PARTS & SERVICE NEWS

REF NO. AA00225A

SUBJECT: IMPROVEMENT OF HYDRAULIC OIL COOLER SYSTEM

PURPOSE: To introduce a modification procedure to prevent hydraulic oil cooler failures.

VLPS0066

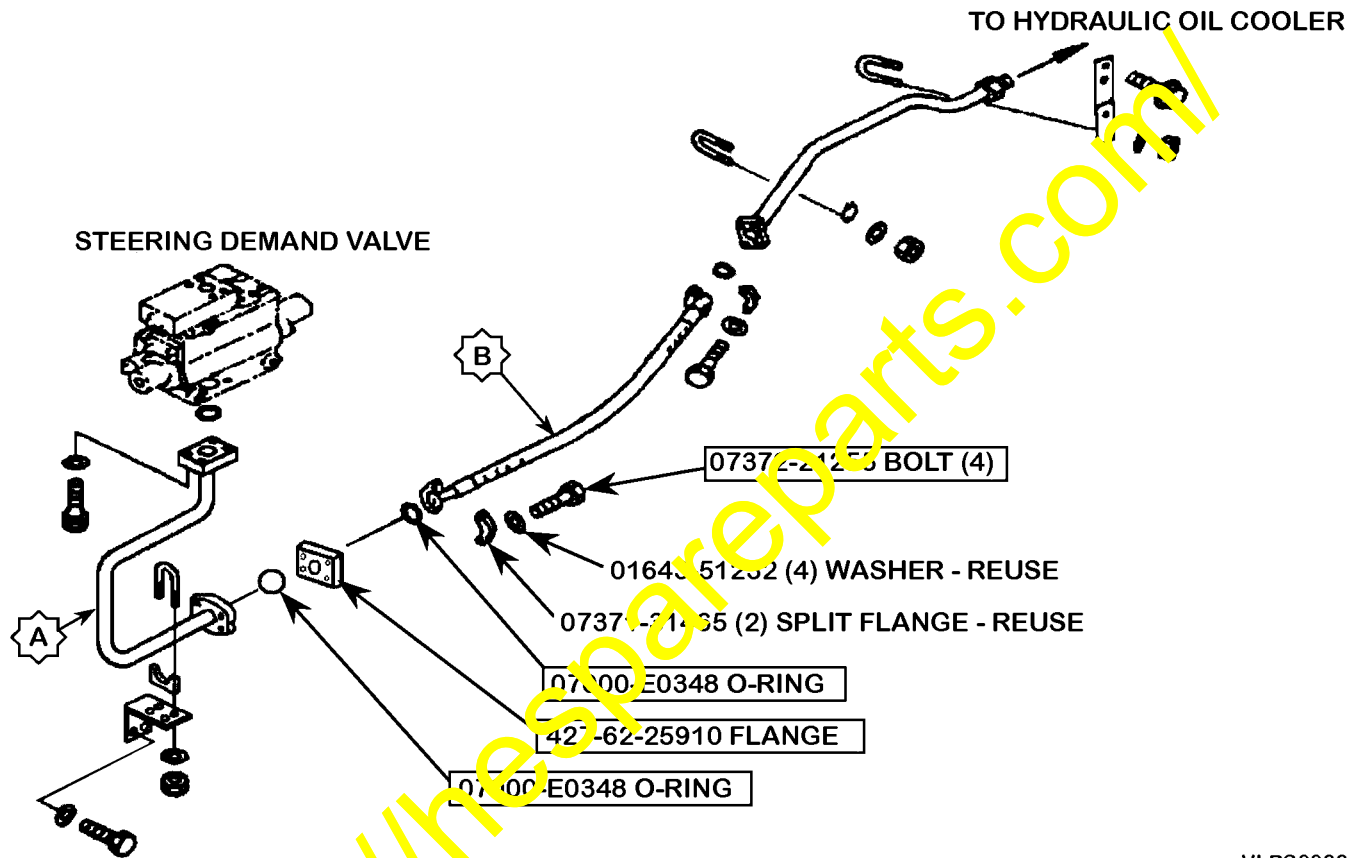
A. Add the flange into the return line of the steering valve piping.

- a. Disconnect hose B from tube A.
- b. Install the new o-ring on the flange, install flange then reassemble hose B to tube A.
Reuse existing split flanges and washers with new bolts for hose installation.

VLPS0092

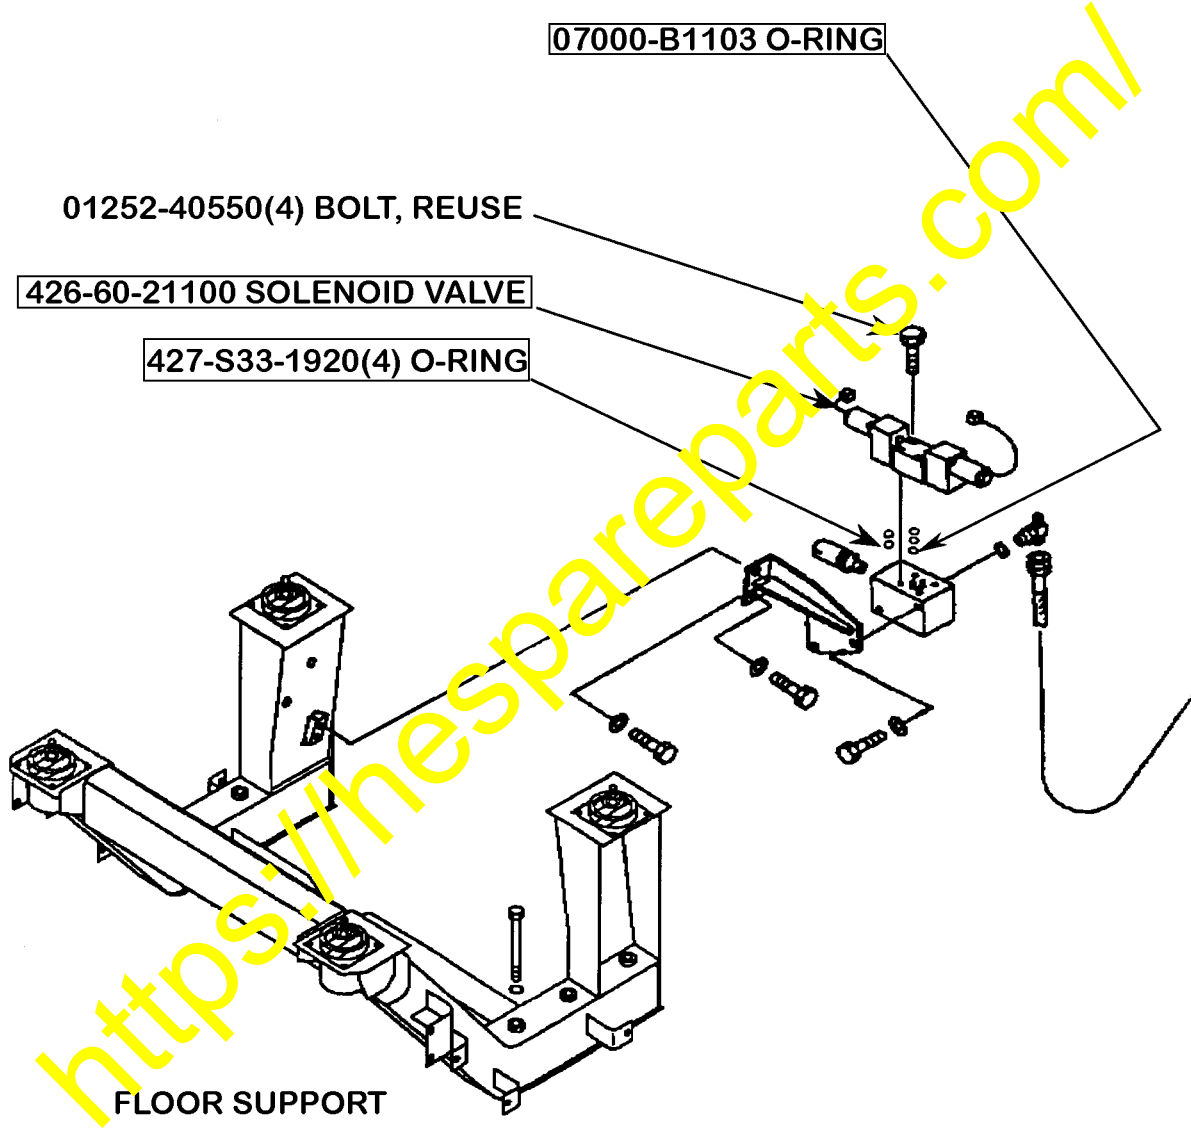
B. Replace the solenoid valve.

- a. Disassemble and remove the existing solenoid valve assembly (427-S33-1911).
- b. Install new solenoid valve (426-60-21100) using o-rings (427-S33-1920 and 07000-B1103) and bolts (01252-40550).

VLPS0093

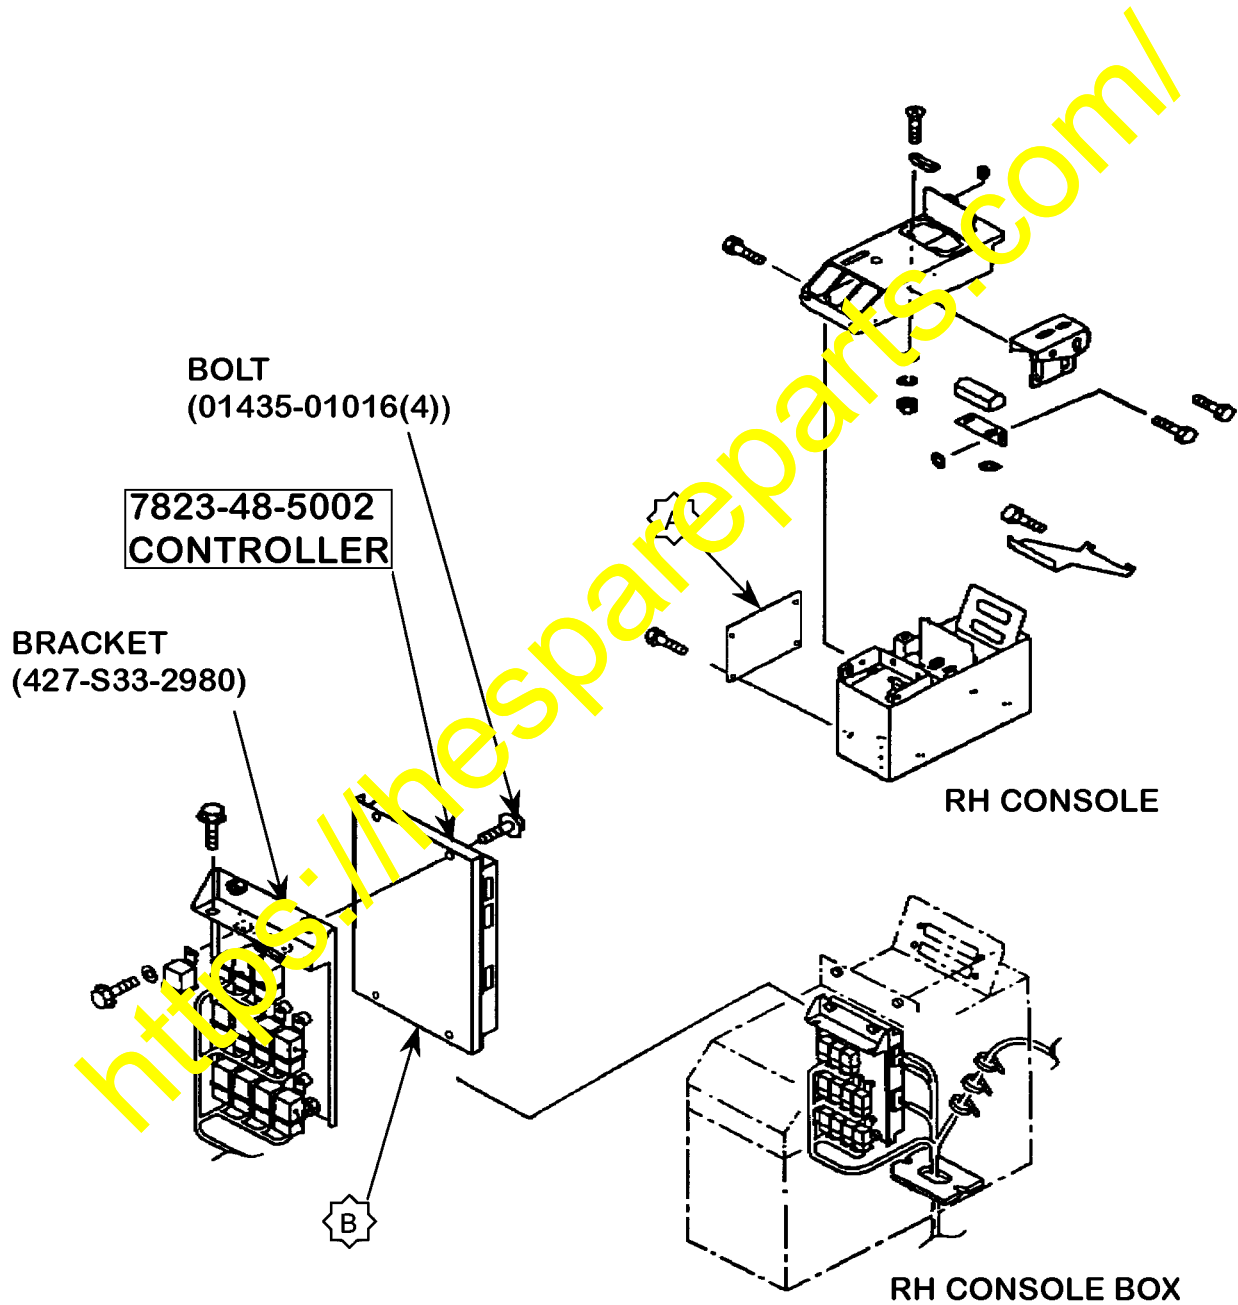
C. Replace the controller.

- a. Remove cover A from right console box in cab.
- b. Remove the existing controller (7823-18-1002) from bracket B in the right console box.
- c. Install the new controller (7823-18-1003). Use existing hardware.
- d. Install cover A to the right console box.
